ORDINANCE 99-48

TO AMEND THE PRELIMINARY PLAN FOR THE SERVICE MERCHANDISE PLANNED UNIT DEVELOPMENT (PUD)
Re: 123 South Kingston Drive
(Marsh Supermarkets, Petitioner)

BLOOMINGTON PLAN COMMISSION
FINAL REPORT
Location: 123 South Kingston Drive

CASE NO.: PUD-55-99
DATE: November 8, 1999

Exhibit #4 Landscape Plan

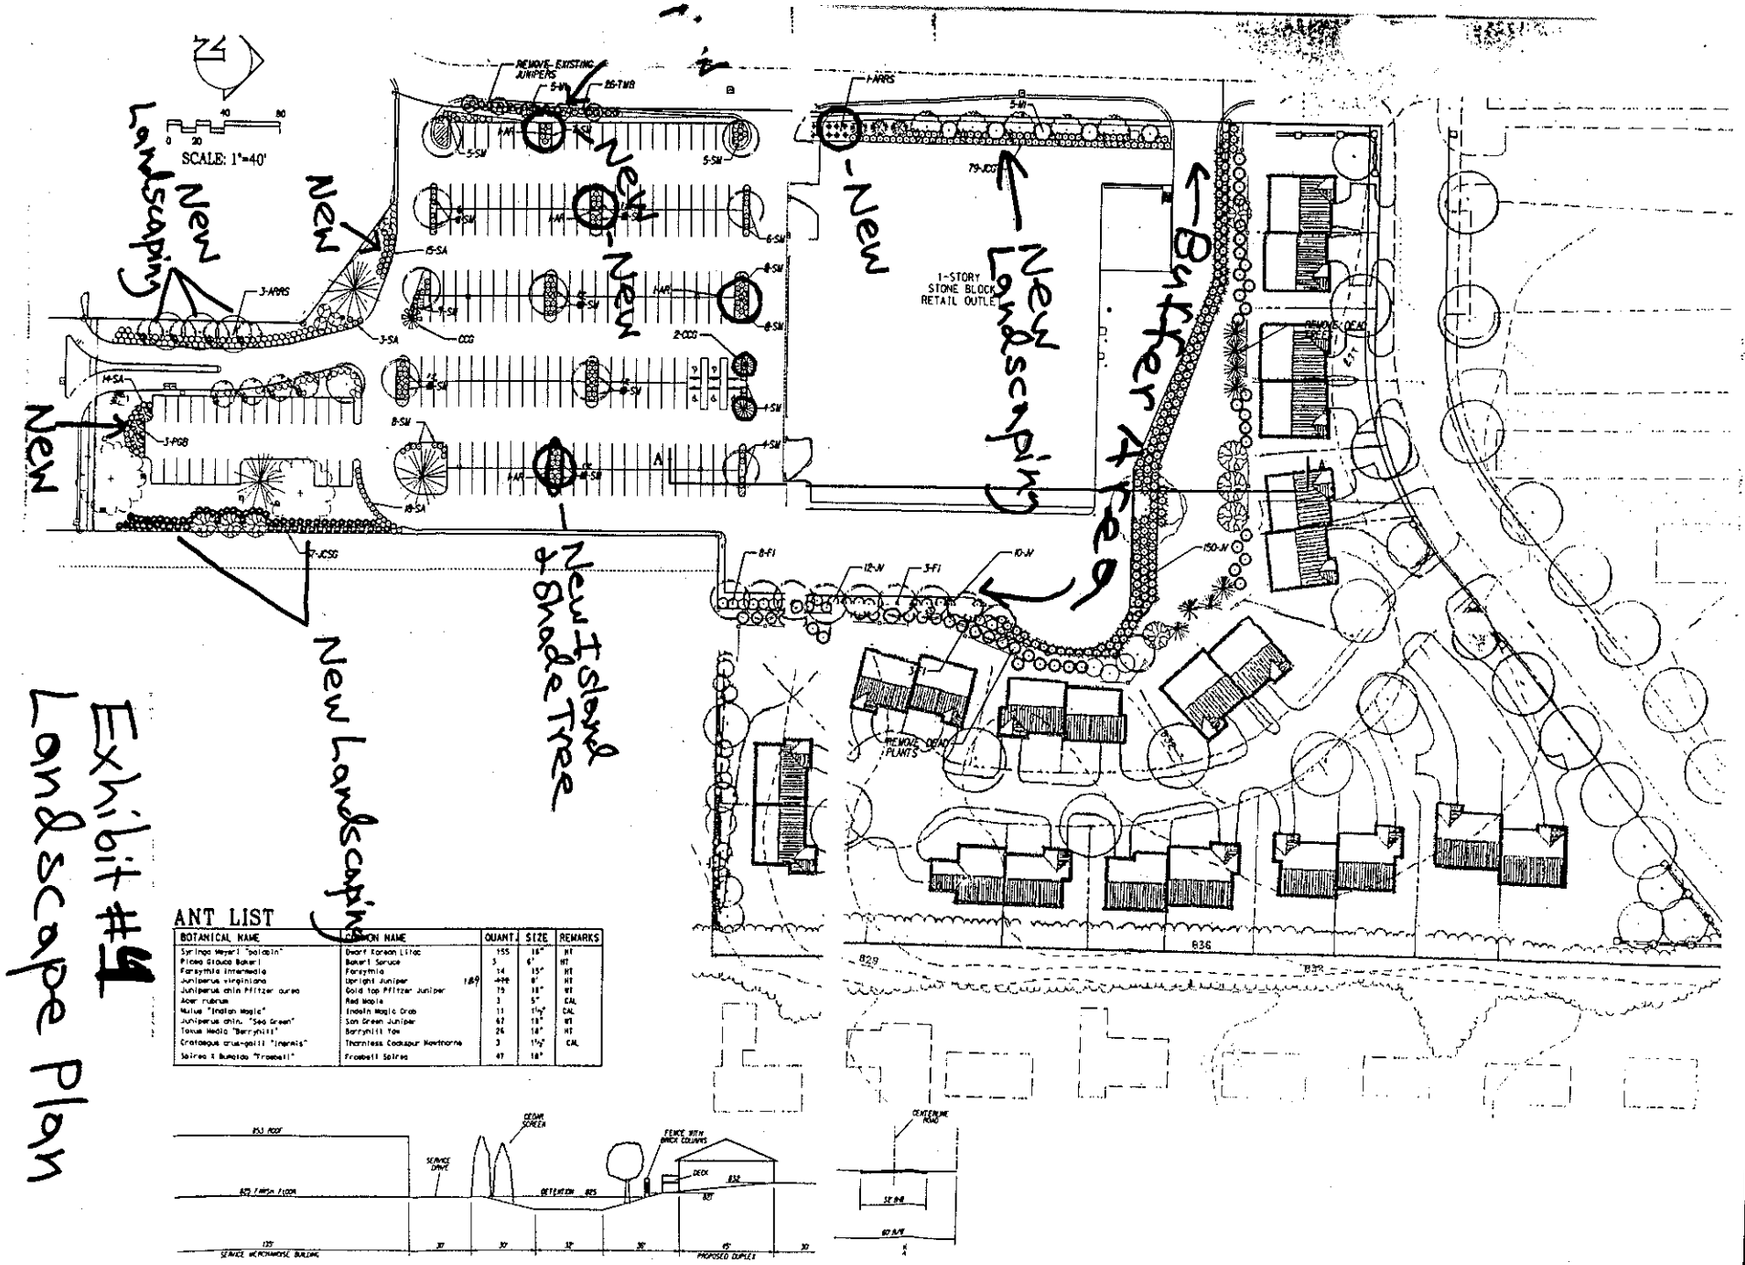
Landscaping Compliance – Since the first Plan Commission hearing, the petitioner's landscape plan has been upgraded to meet code requirements (Please note Exhibit #4). More specifically, the petitioner will be providing the following landscaping upgrades on the property:

a. **Landscaped Islands** - Three new landscaped islands will be installed within the existing parking lot.
b. **Parking Lot Trees** – Four new shade trees and two new ornamental trees will be added to the interior of the existing parking lot.
c. **Parking Lot Shrubbery** – 118 new shrubs will be added to the interior of the existing parking lot.
d. **Perimeter Trees** – Four new shade trees and 10 new ornamental trees will be added to the southern and western perimeters of the site.
e. **Perimeter Shrubs** – Not counting specific residential buffering requirements which will be discussed in the next section of this report, 218 new shrubs will be planted along all sides of the existing site.

2. **Landscaping Compliance** – Since the first Plan Commission hearing, the petitioner's landscape plan has been upgraded to meet code requirements (Please note Exhibit #1). More specifically, the petitioner will be providing the following landscaping upgrades on the property:

a. **Landscaped Islands** - Three new landscaped islands will be installed within the existing parking lot.
b. **Parking Lot Trees** – Four new shade trees and two new ornamental trees will be added to the interior of the existing parking lot.
c. **Parking Lot Shrubbery** – 118 new shrubs will be added to the interior of the existing parking lot.
d. **Perimeter Trees** – Four new shade trees and 10 new ornamental trees will be added to the southern and western perimeters of the site.
e. **Perimeter Shrubs** – Not counting specific residential buffering requirements which will be discussed in the next section of this report, 218 new shrubs will be planted along all sides of the existing site.

3. **Residential Buffering** – Based on the existing condition of the site, buffering is clearly needed along the northern side of the existing building. This buffering will soften the view of the rear façade, physically screen loading activities from view, and act as a partial sound barrier for both existing neighbors and the future users of the vacant property to the north. To this end, the petitioners have committed to planting 189 8-foot tall upright junipers along the property's northern and eastern interface. This buffering is also depicted in Exhibit #1. In

Exhibit#2
Pedestrian
Accommodations
New
Sidewalk
Longview Ave
Existing
Sidewalk
Irrigation
New
Walkway
SECTION A-A
SCALE: 1"=40'
Existing
Sidewalk
East 3rd St.
Exhibit #5
Pedestrian
PROPOSED MARSH
ZONING AMMENDMENT
LANDSCAPE
PLAN
09/24/99
196SWS

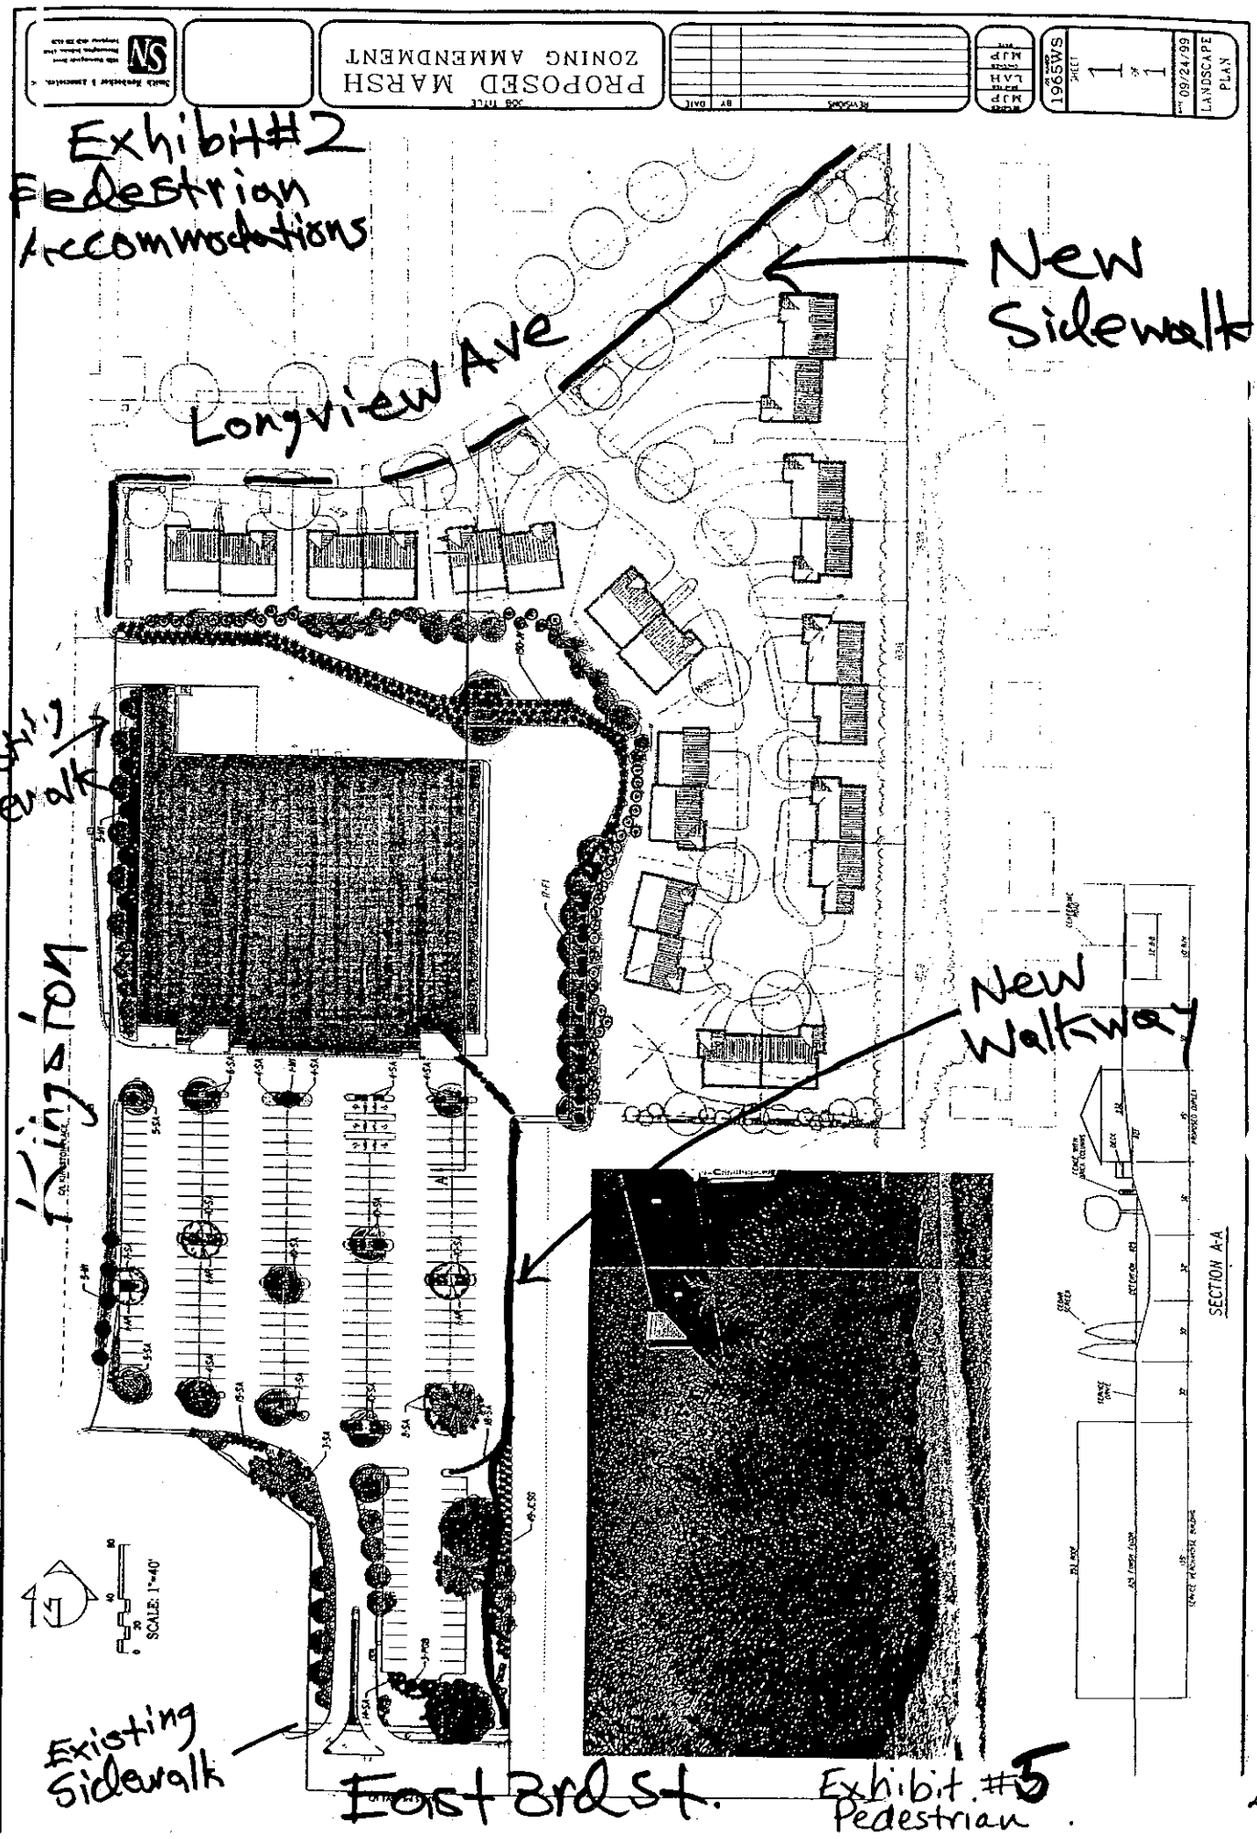
The second accommodation is in response to Plan Commissioner concerns regarding the pedestrian accessibility of the Marsh storefront to the existing sidewalk along East 3rd Street. To this end, the petitioners have committed to constructing a narrow concrete walkway between East 3rd Street and the Marsh storefront along the entire east property boundary with the car dealership. This walkway could be widened to a full 5 foot sidewalk either through a cooperative effort between the City, petitioner, and adjacent property owner or as an explicit requirement accompanying a future land use petition on the car lot. Both this

accommodation as well as the Longview/Kingston sidewalk are illustrated in Exhibit #2, labeled "Pedestrian Accommodations." As a condition of this project's approval, both pedestrian accommodations must be installed by the petitioner and inspected by City staff prior to a final occupancy permit for the grocery store.

PUD-55-99
Building Elevation

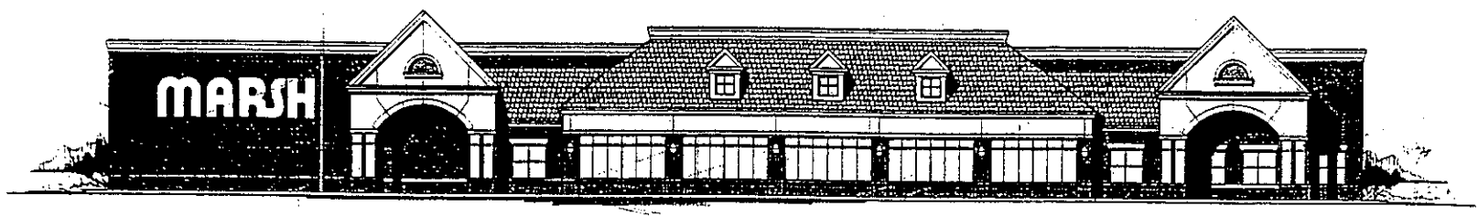
Architecture – Staff is pleased with the petitioner's proposed front façade and believes it represents an improvement over the existing Service Merchandise building.
